1516 Rutland Street Houston Heights West

CERTIFICATE OF APPROPRIATENESS

Proposal: Alteration - Addition

September 11, 2025 HPO File No. 2025 0251 1516 Rutland Street Houston Heights West

ROOF PLAN

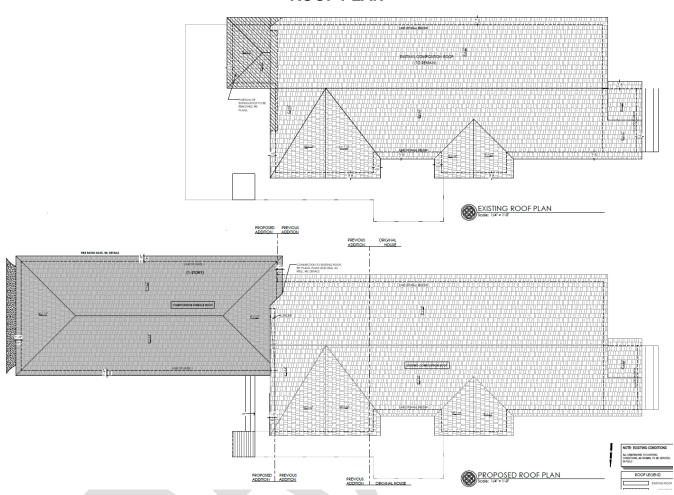
Recommendation: Approval with conditions: That the addition's roof and how it connects to the existing roof be

fixed to avoid pooling.
